Title		
Size A4	Number	Revision
Date: 10.29.2026		Sheet of
File: C:_Proj\..\FoxSky.Janus.SchDoc		Drawn By:

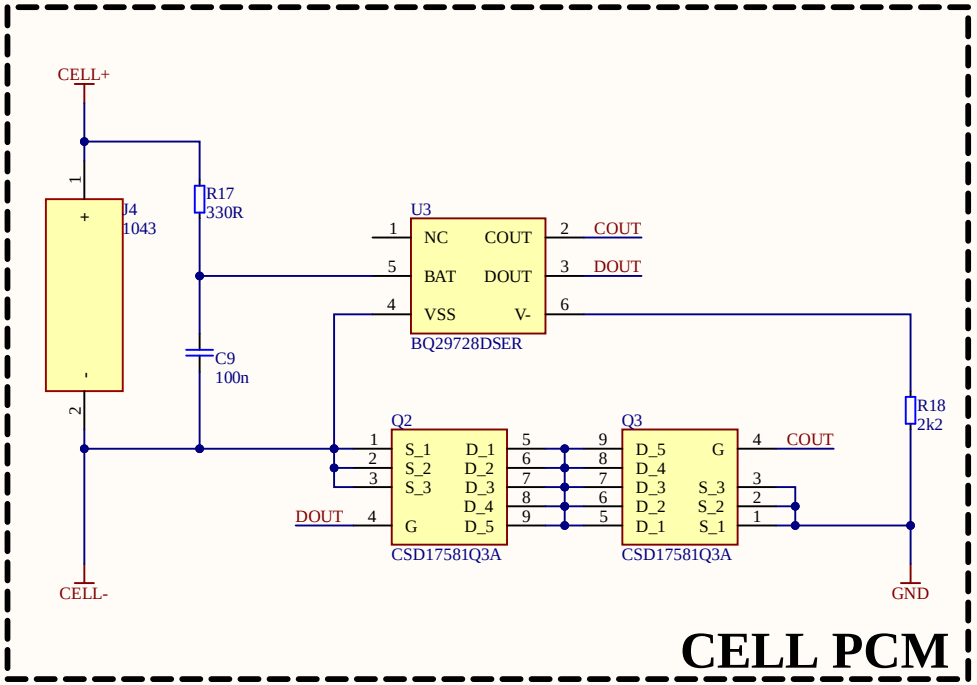
place charging indicating diodes and maybe termistor (103AT) to TS, for now only 10k will replace it

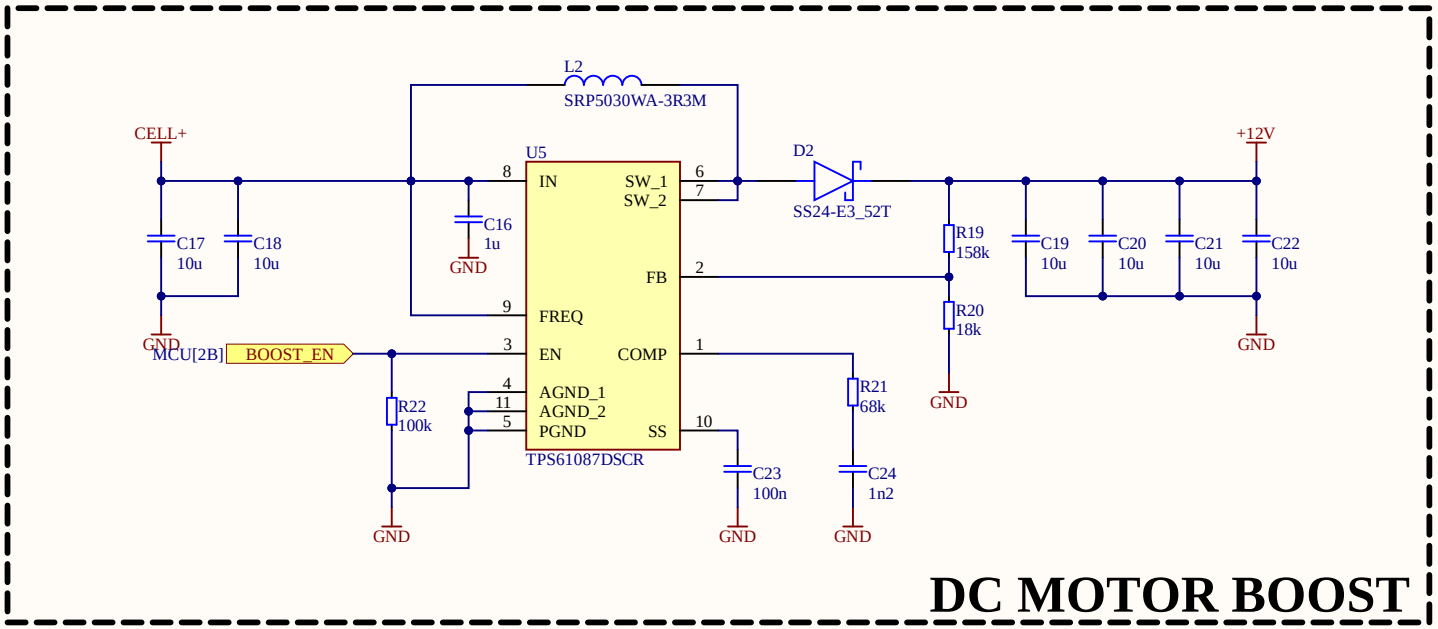
sa we tend to use electromagnetic clutch we need potentially use another 12V boost if the current supply isnt enough

DC MOTOR DRIVER

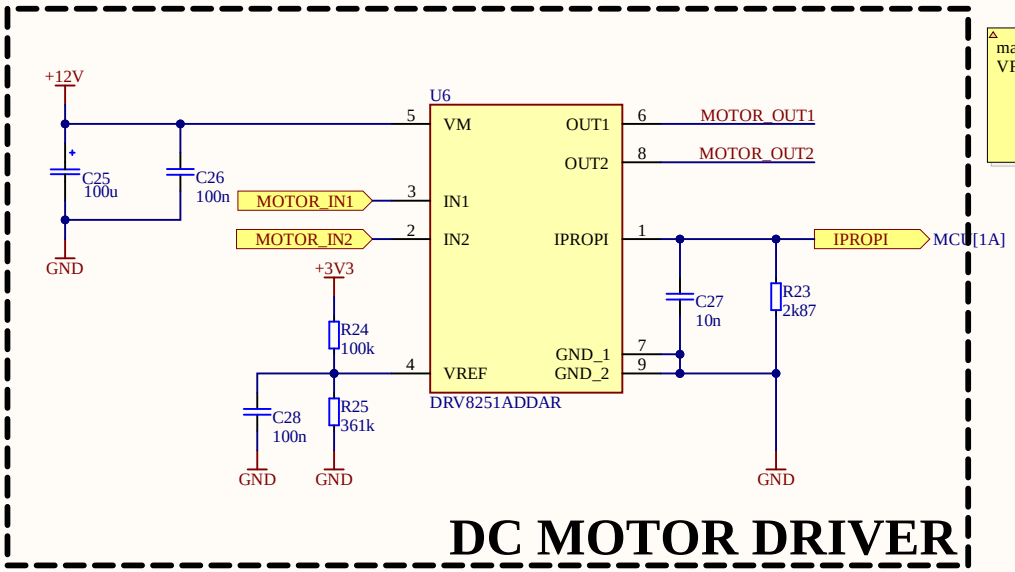
maybe use BOOST_EN to power the VREF divider
